Heatons and Reddish Area Committee

DEVELOPMENT APPLICATIONS

DC/083249

Vauxhall Industrial Estate, Greg Street, South Reddish, Stockport, SK5 7BR

Site Layout

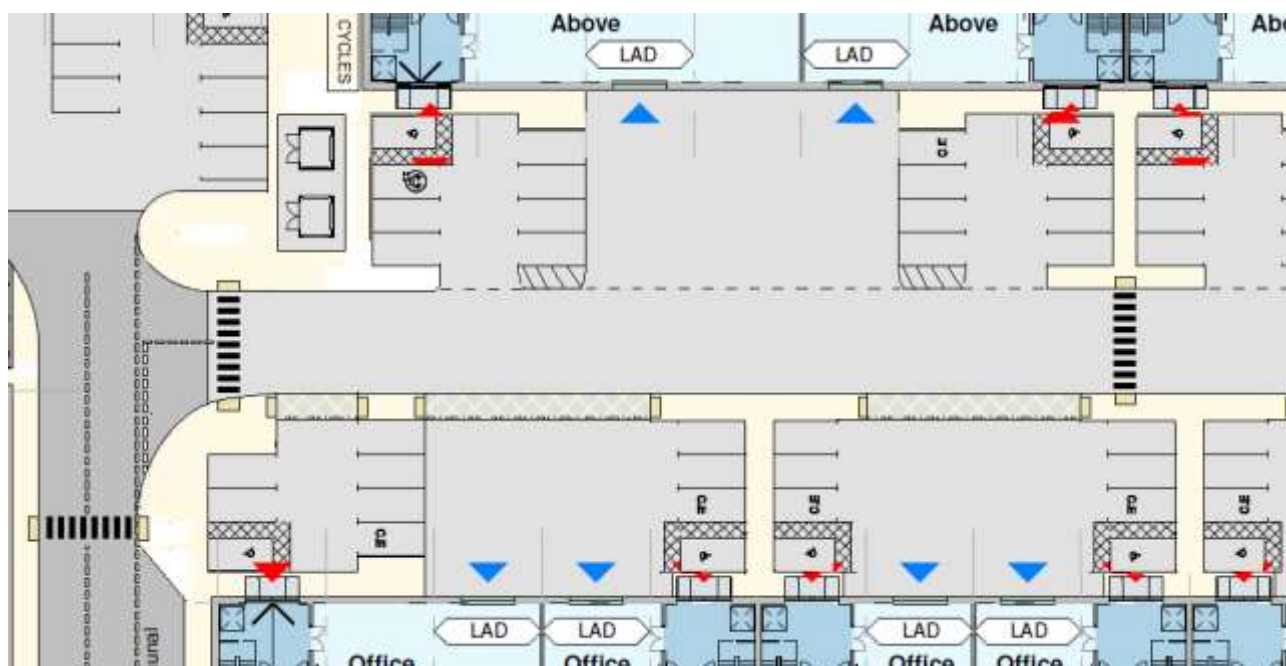
The development would comprise of 28 no. employment units grouped around a central yard, with parking and service areas located between the buildings. Whilst footways are proposed along parts of the first section of the access drive, in other parts of the site, pedestrian routes would comprise of delineated routes across the service yards. With gates proposed at the site access, all the site would be private.

It is therefore considered there is a need for the site layout to be amended so as to address the issues outlined. This should be possible without significant amendments to the site layout. The drawing below provides an indication of what would be acceptable. This could be replicated across the site.

I therefore recommend that the application is also deferred to allow the applicant to revised the site layout with the aim of addressing these issues.

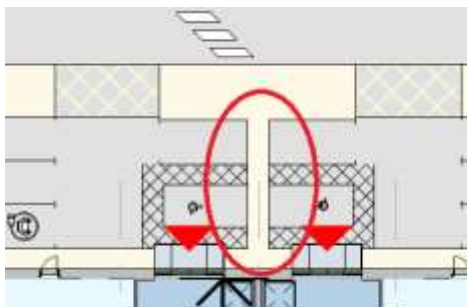
- 2) There is no pedestrian route past Unit 3E and the footpath in front of Unit 5A has a pinch point (see plan below).

- 3) The pedestrian crossing on the main site access conflicts with the loading bay (see plan above)
- 4) The tie in between the access and the layby on the site access road is sub-standard (see plan below). The kerb line at the access should tie in with the outer extent of the layby / the dashed in and then splay in (or similar).
